## Comment Set 40

Re: A.02-09-043: Comments on Draft Environmental Impact Report  
for the Proposed Jefferson-Martin 230 kV Transmission Line Project

## Responses to Comment Set 40 – Davis Wright Tremaine for the 280 Corridor Concerned Citizens Group

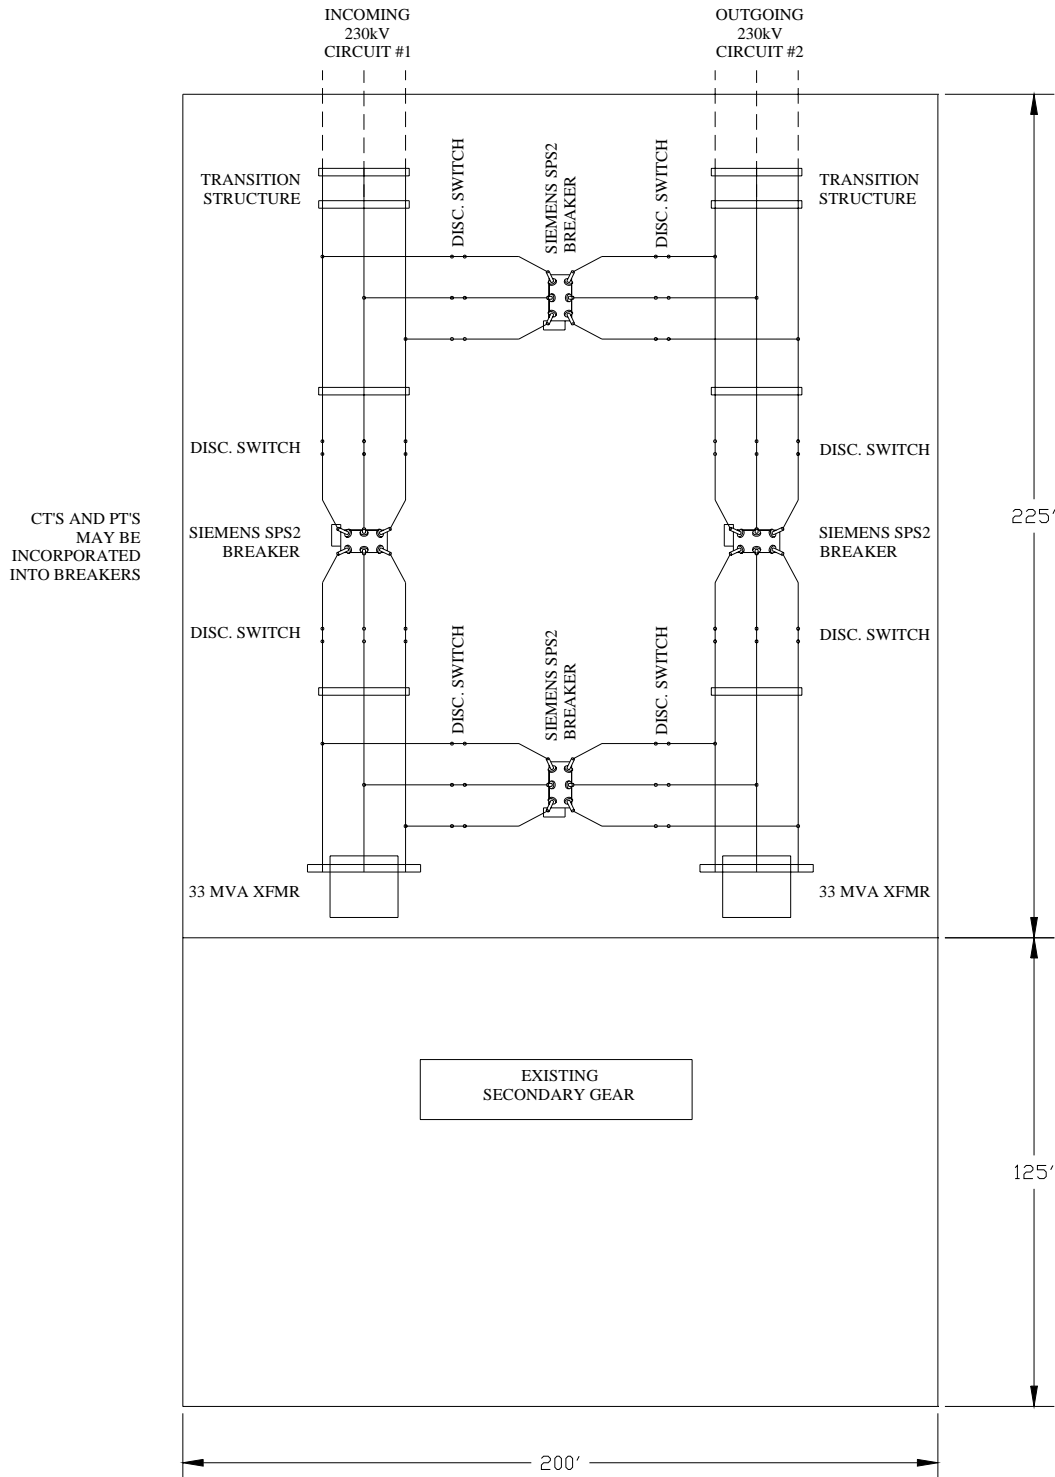
We have created a plan view of the proposed layout of the new equipment at the Ralston Substation, for your use in evaluating the Watershed Restoration Alternative. The proposed view was created in response to the concerns of spacing and land requirements.

**EQUIPMENT REQUIRED AT RALSTON SUBSTATION:** The 230 kV line would enter the Ralston Substation underground, as described in our response to Staff’s data request, to a transition structure and then to a 230 kV ring bus configuration. The 230 kV line would then go through a second transition structure, exit the substation, and return underground to Skyline Boulevard in the same trench as the incoming 230 kV line (with appropriate separation between both 230 kV duct banks). The existing transformers would be replaced with two 33 MVA 230/12 kV transformers which would interconnect with the existing and three new proposed 12 kV feeders. The new 12 kV feeders would be installed in the Ralston Substation to serve the

**SPACE REQUIREMENTS AT RALSTON SUBSTATION:** The existing Ralston Substation footprint is approximately 0.6 acre (125 feet x 200 feet or 25,000 square feet). We believe that the attached proposed layout will require just over one additional acre of space (225 feet x 200 feet or 45,000 square feet), resulting in total land mass for the Ralston Substation of approximately 1.6 acres (350 feet x 200 feet or 70,000 square feet). DEIR Figure B-14 shows that there is sufficient space contiguous to the Ralston Substation to expand its size sufficiently to accommodate the new equipment we propose.

40-18 As stated in Response to Comment 40-1, the alternatives analysis presented in the Draft EIR was comprehensive and more than fully compliant with CEQA in presenting a reasonable range of alternatives. Despite this, the newly suggested Watershed Restoration Alternative (WRA) as defined in this comment and as supplemented by later submittals to the CPUC by the 280 Citizens group, has been added and considered in this Final EIR. Section 4.2.8 of the Alternatives Screening Report (EIR Appendix 1) presents a description of the alternative (expanded from the comment letter based on commenter response to requests from the CPUC to clarify aspects of the alternative that were not fully defined in the original letter). This analysis considers whether the alternative meets the CEQA requirements regarding project objectives, feasibility, and environmental impacts (as defined in Response to Comment 40-13). In addition, a detailed set of maps of the WRA has been developed and are presented in Appendix 1 as Figure Ap.1-8a and Ap.1-8b.
